**FITNESS ROOM REVISION 05-20-2021**

**0/1 - GARAGE & LOBBY FLOOR PLAN**

**A101**

OVERALL GARAGE & FIRST FLOOR PLAN

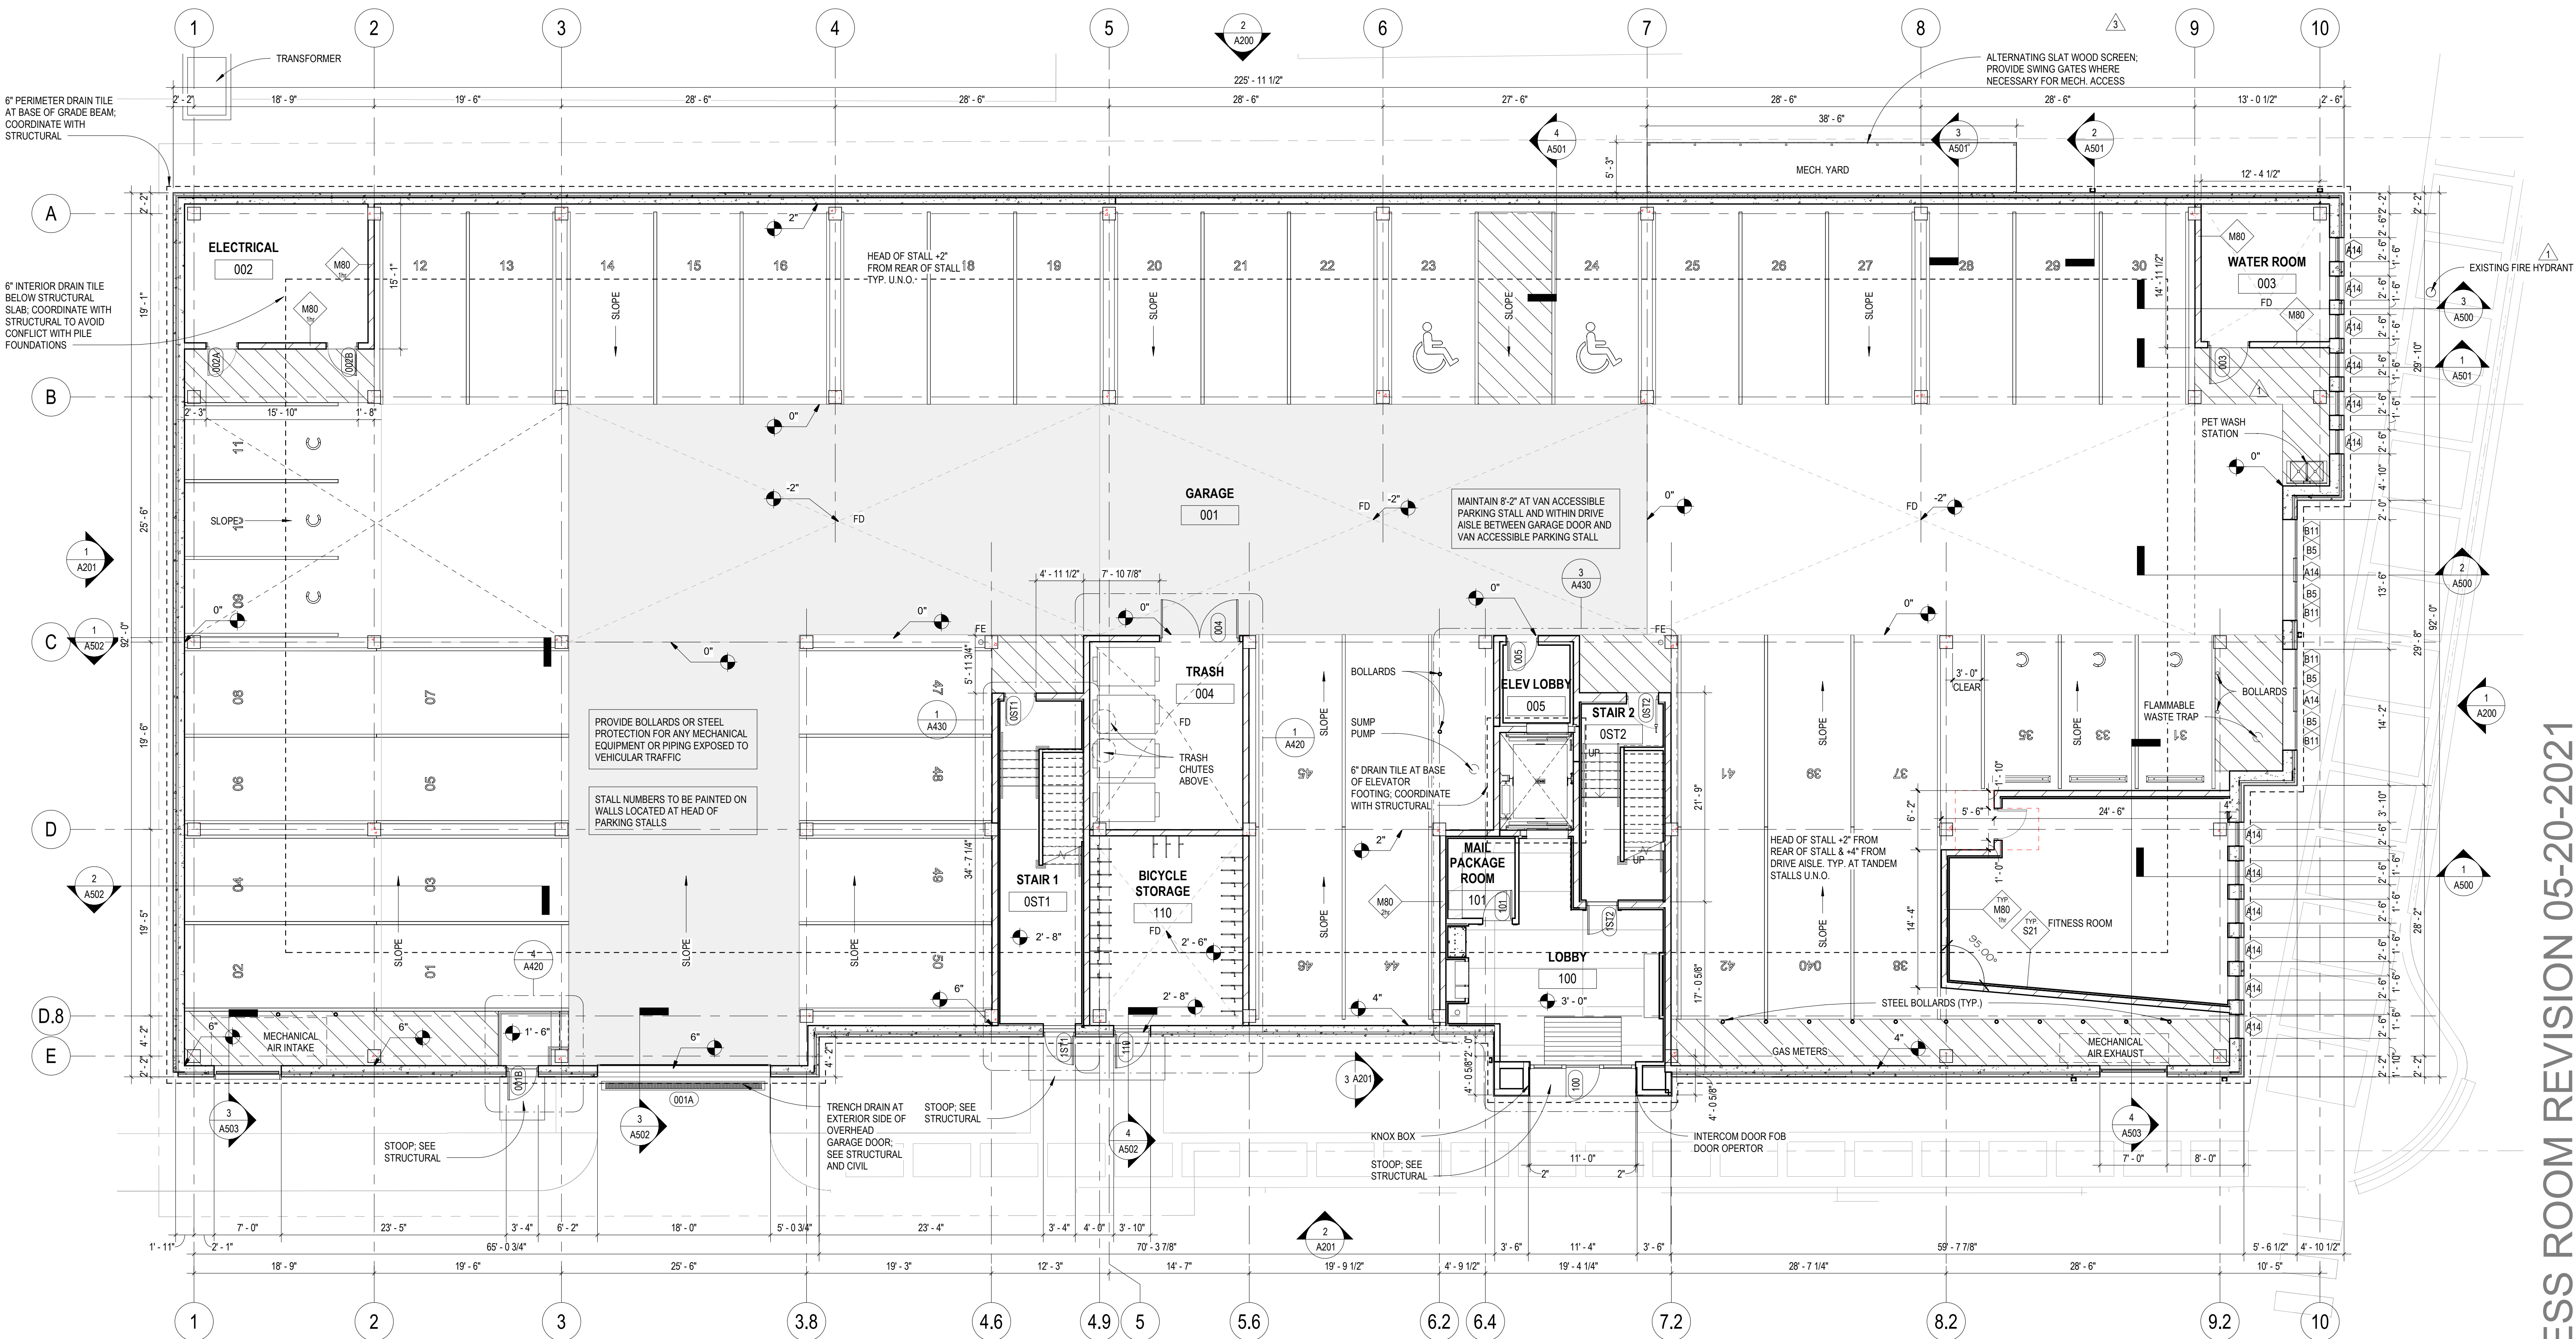
ACCESSIBLE STALLS	2
COMPACT STALLS	3
TYPICAL STALLS SINGLE	21
TYPICAL STALLS TANDEM	24
<b>TOTAL</b>	<b>50</b>

ACCESSIBLE STALLS	2
COMPACT STALLS	6
TYPICAL STALLS SINGLE	21
TYPICAL STALLS TANDEM	18
<b>TOTAL</b>	<b>47</b>

REVISED DESIGN REMOVES (3) TYPICAL STALLS THAT WERE IN TANDEM AND ALTERS (3) STALLS TO BE COMPACT. WHERE THE TANDEM STALLS WERE PREVIOUSLY LOCATED A FITNESS ROOM HAS BEEN PROPOSED. THIS ROOM UTILIZES THE WINDOWS ALONG LAKE STREET AND WOULD BE A VALUE TO THE RESIDENTS OF THE BUILDING.
